Addendum #1

RE: REQUEST FOR TENDER #2024-137-P01947
Hess Street Elementary School – Renovation Project

Addendum No. 1

PROJECT:	HWDSB Hess Elementary School	DATE:	April 24 th , 2024
PROJECT #:	23035	FROM:	Binayak Raj Maurya
TO:	NGA Architects	ATTENTION:	Ivana Paukovic

3 PARTIAL GROUND FLOOR NEW UNIVERSAL W/R & NEW SEMINAR ROOM H.V.A.C. DEMOLITION
SCALE: 1/4"=1'-0"

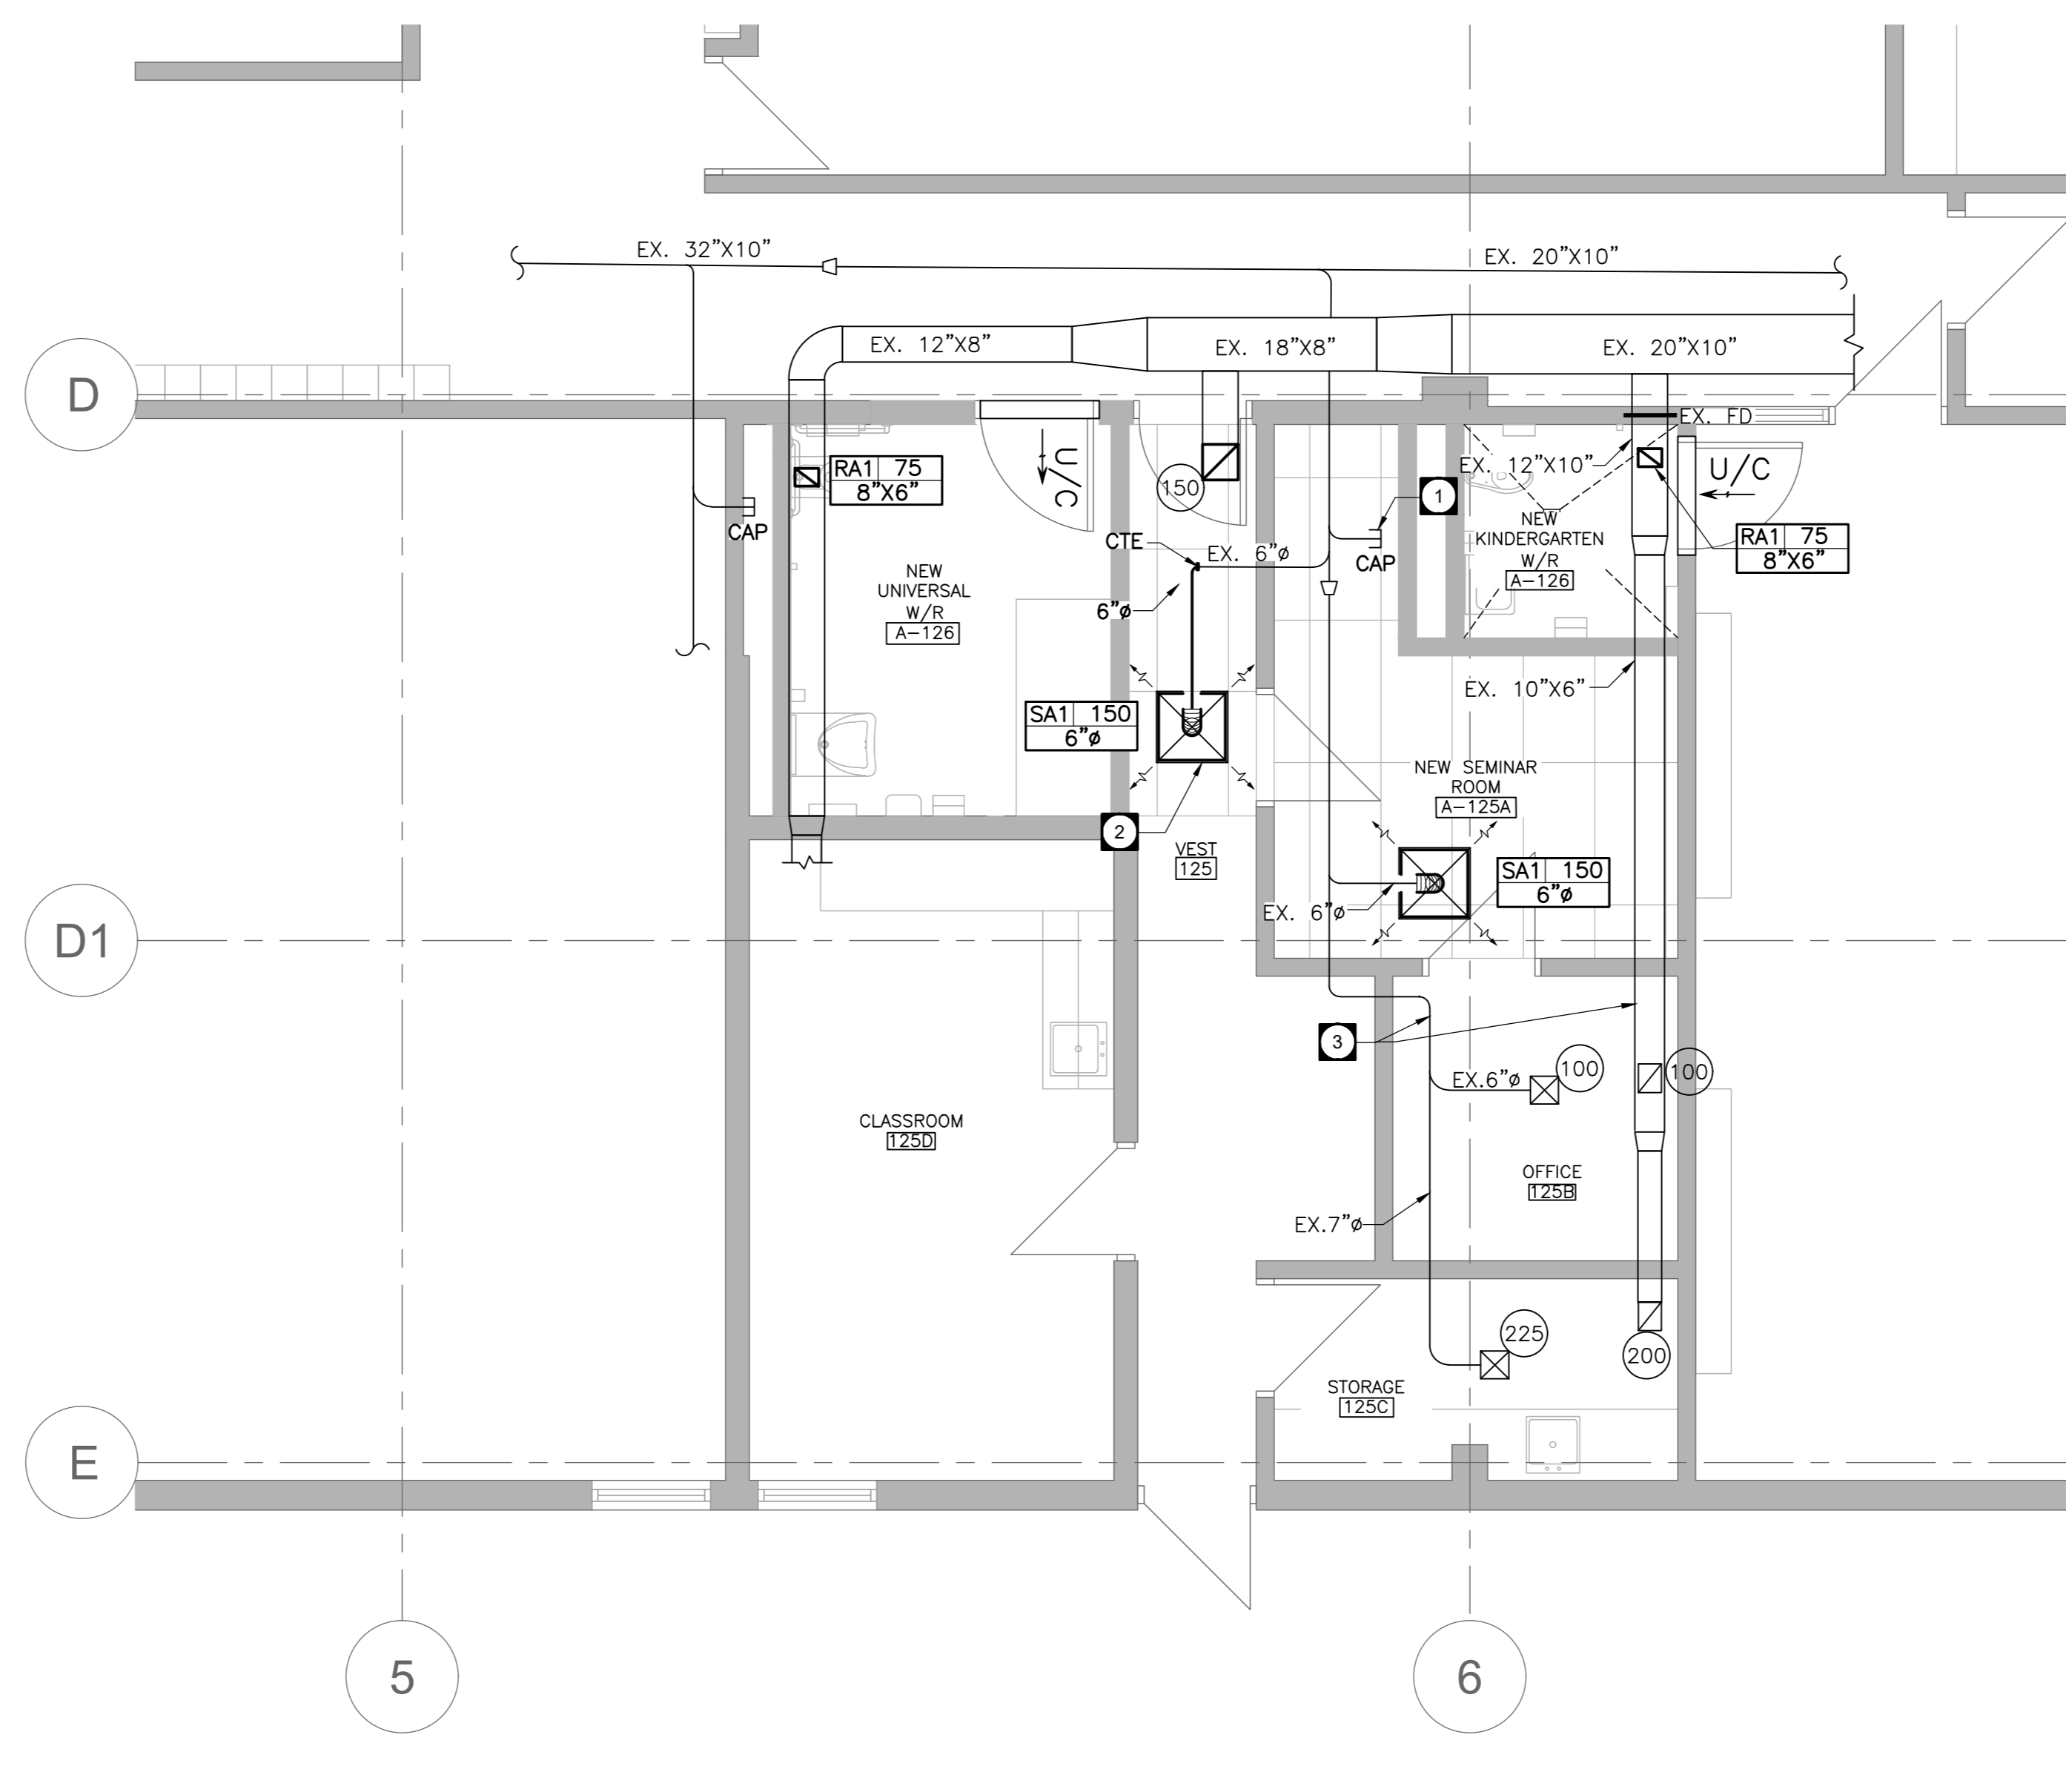
- 1) **Question:** On drawing M1.01, demo and new gym layout there is a reference to note 5. There isn't a note 5 under the new drawing notes.

- 4) **Question:** In various places on the drawings there are cross hatched symbols along the walls with no notes or references to what these are. What are these?

1.2 Refer to Mechanical Drawing M 1.01 Rev. C

- New note number-5 stated as “PROVIDE NEW TRANSER AIR GRILLES AS INDICATED” was added in the new drawing notes table.
- “EX. HEATER TO REMAIN” tag has been shown at the locations of existing wall fin heaters in Gymnasium-105.

Answer: Added note for new transfer grille. Refer to attached Addendum No. 1 by CK Engineering Inc dated April 24, 2024.

Answer: Existing heaters to remain. Refer to attached Addendum No. 1 by CK Engineering Inc dated April 24, 2024.

SHEET NO.
M 1.02

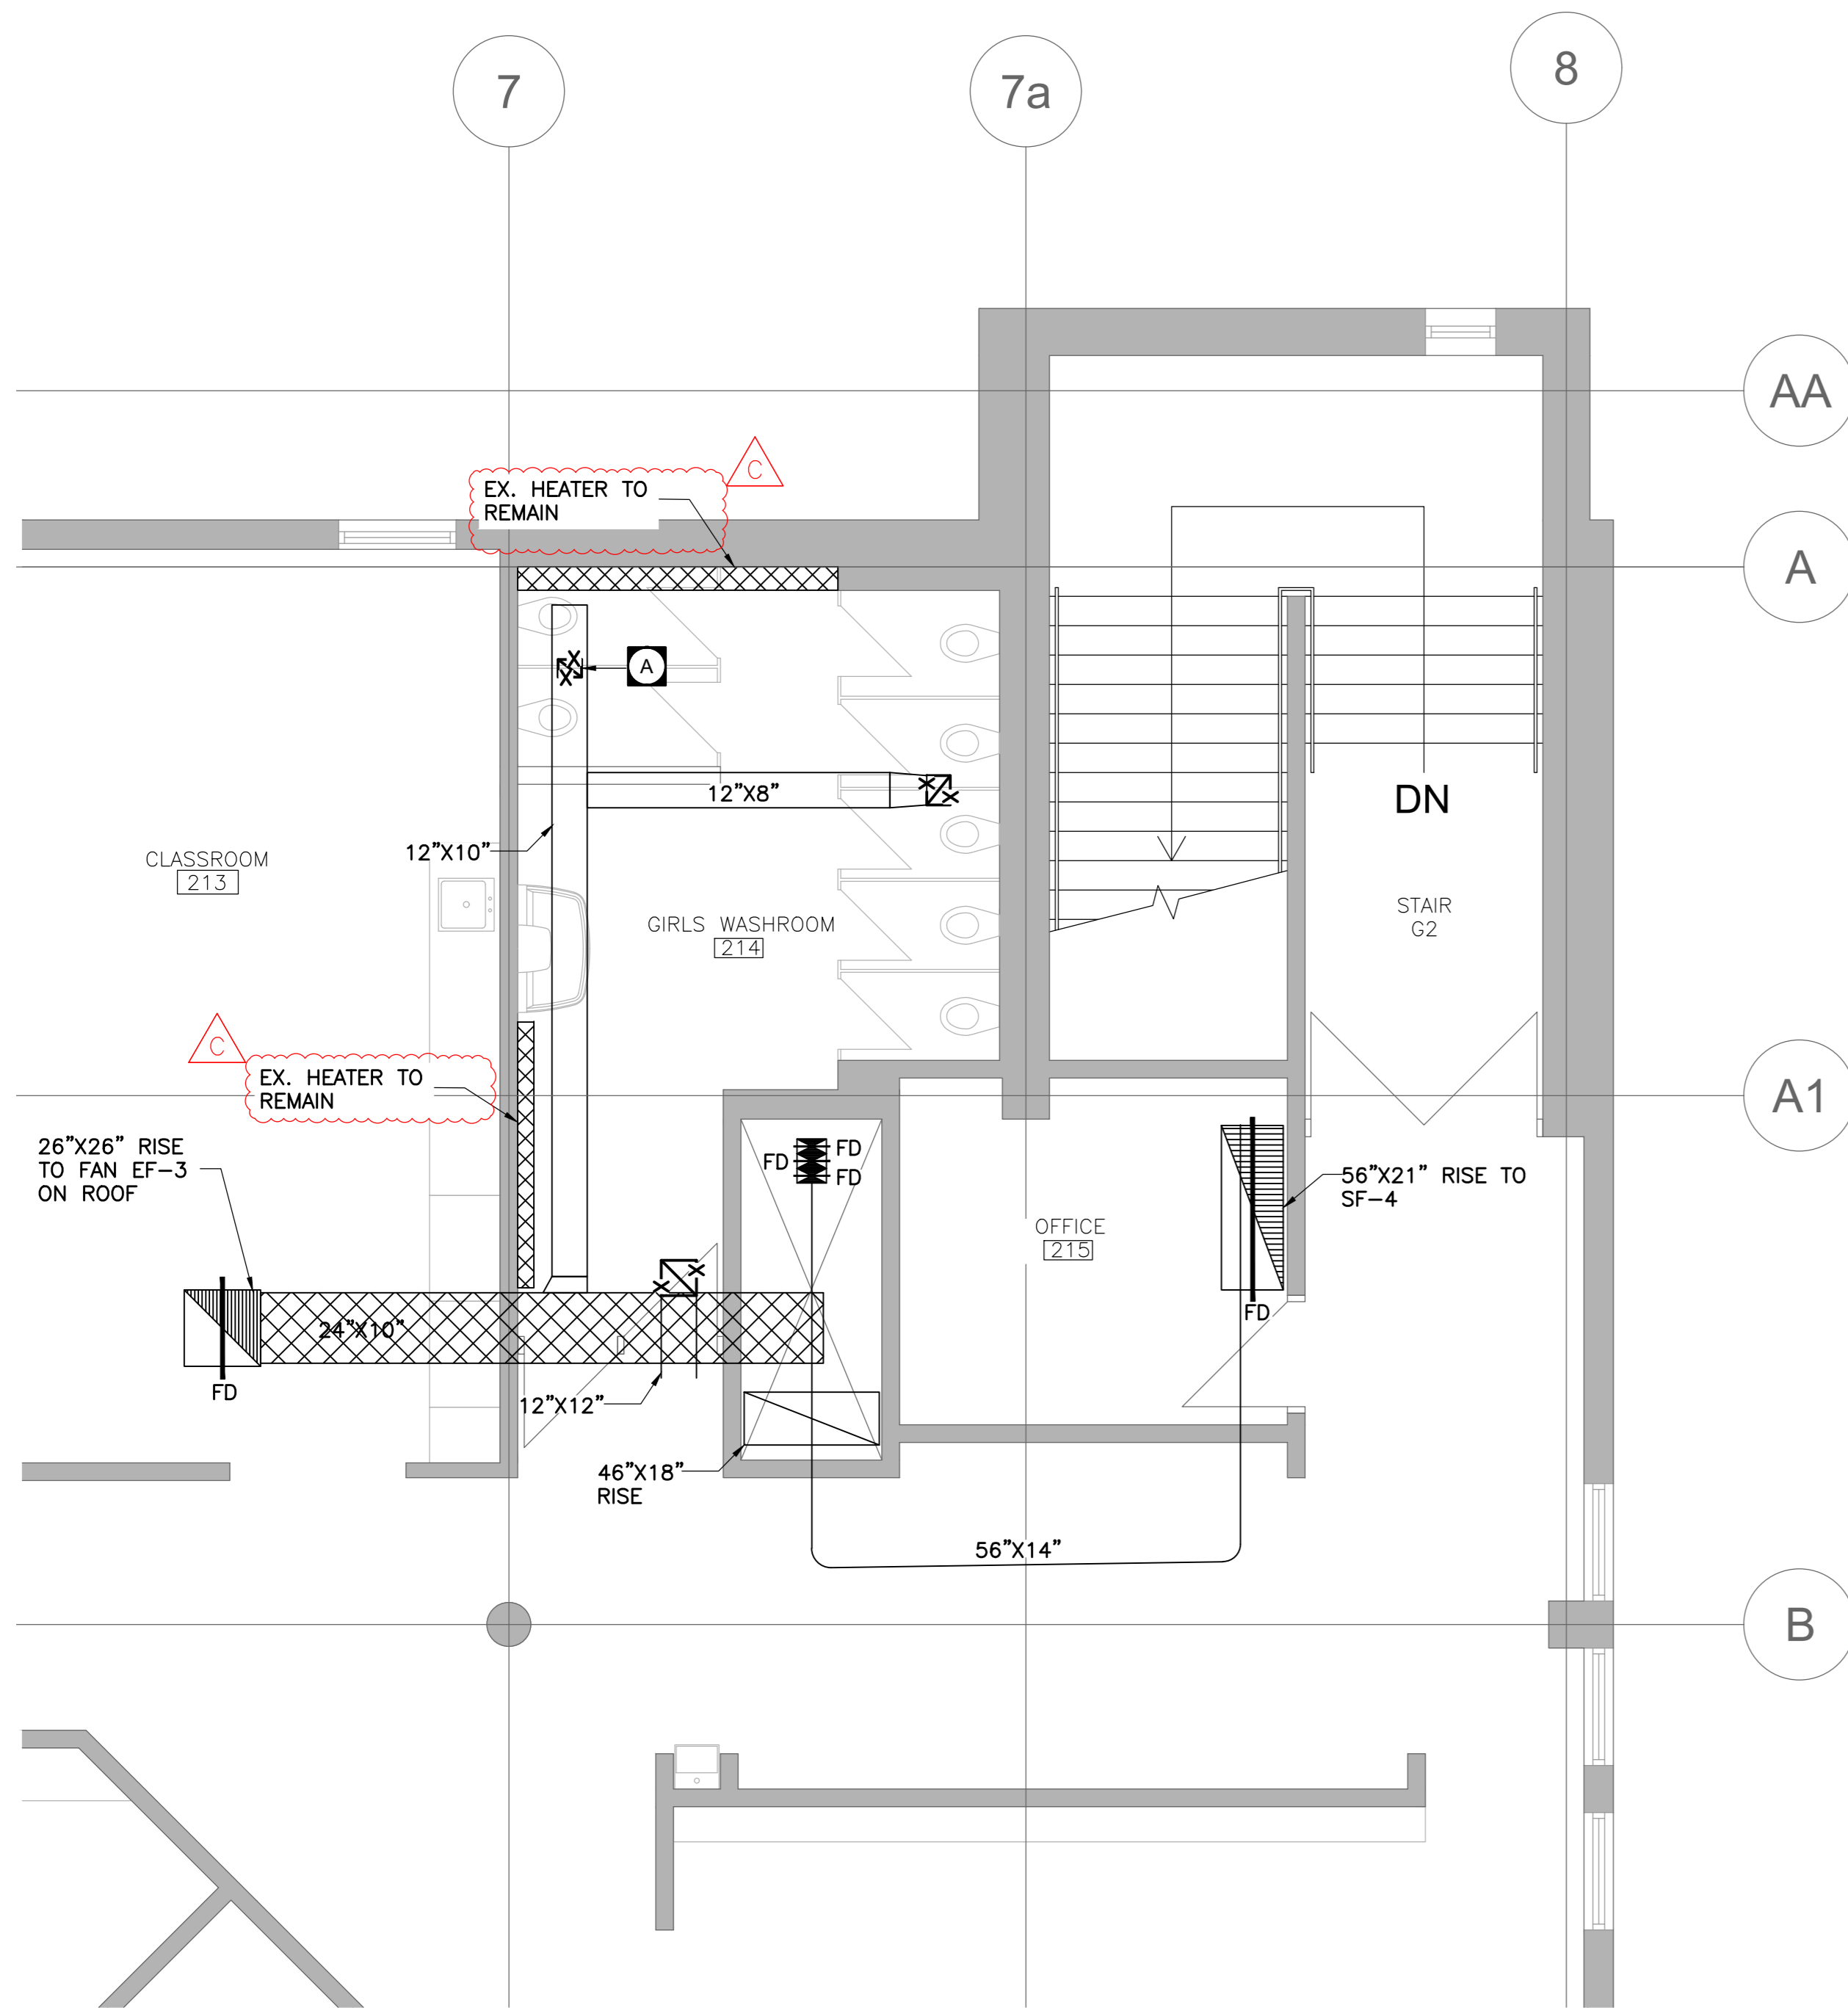
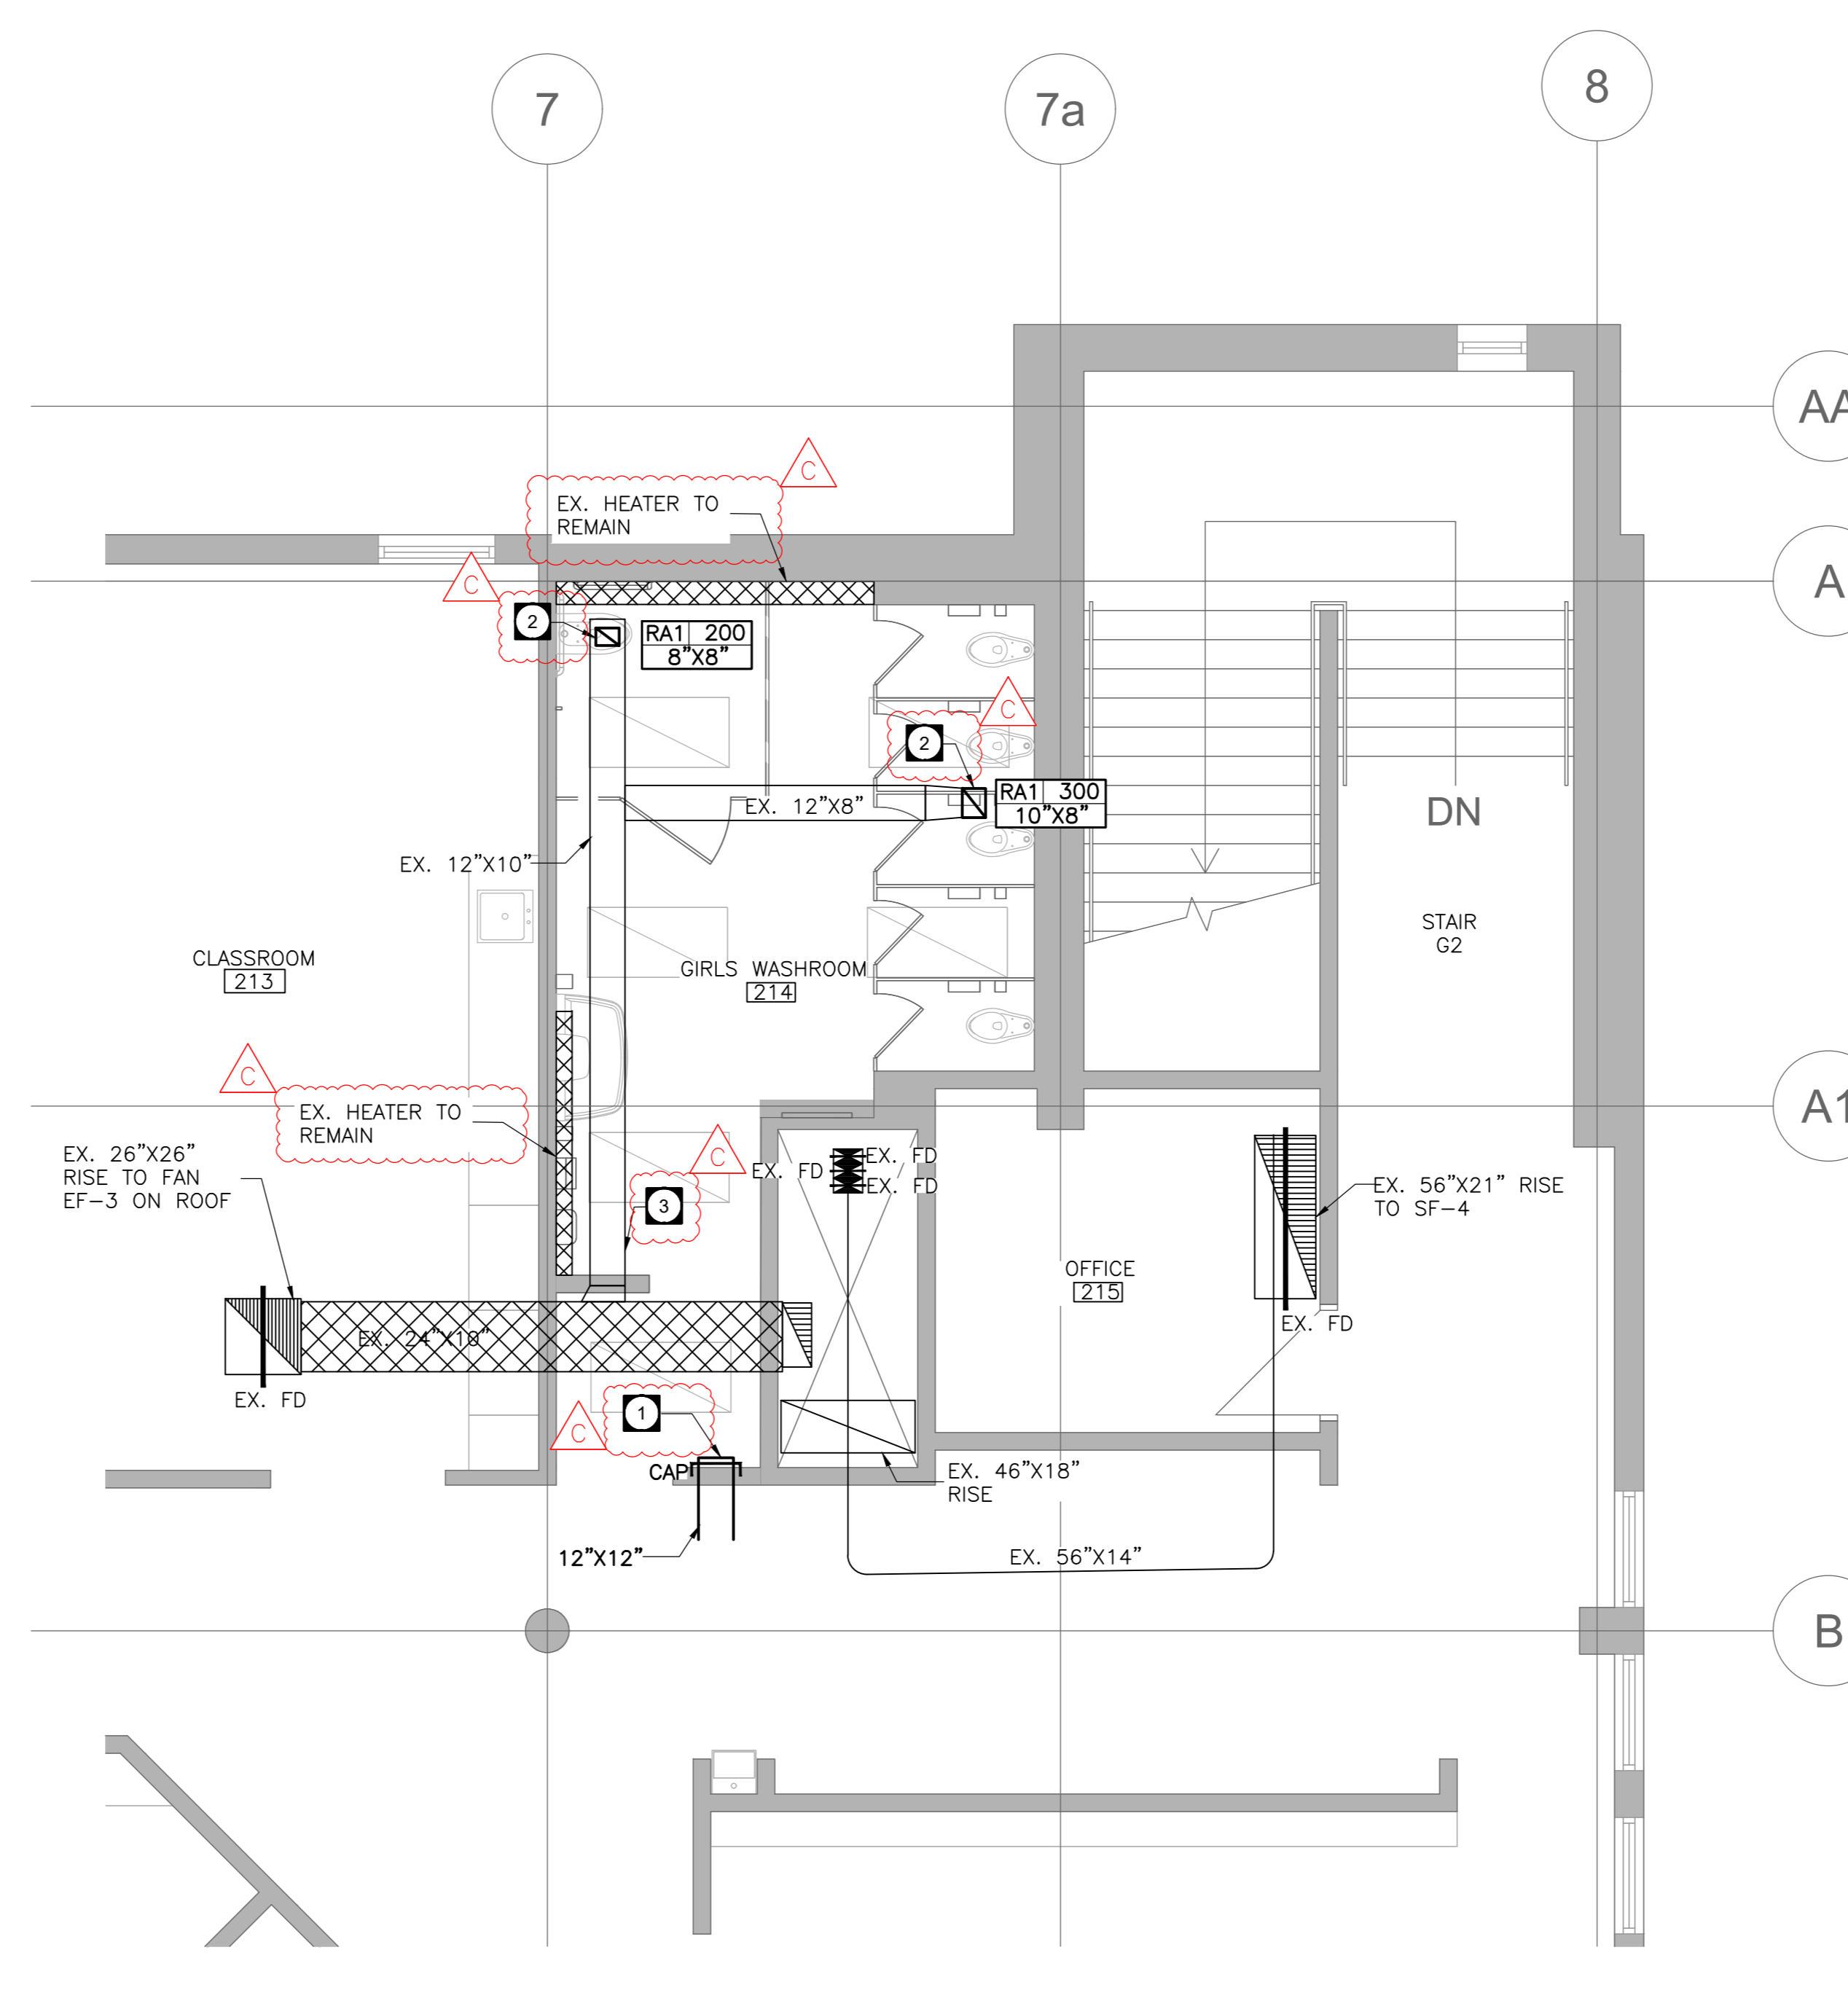
- 2) **Question:** On drawing M1.02, second floor girls w/r new duct layout, there is reference to a note 4. There isn't a note 4 under the new drawing notes.

1.3 Refer to Mechanical Drawing M 1.02 Rev. C

- “EX. HEATER TO REMAIN” tag has been shown at the locations of existing wall fin heaters in second floor Girls’ WR and Boys’ WR.
- Note numbers have been updated in the second floor Girls’ WR New HVAC Layout.
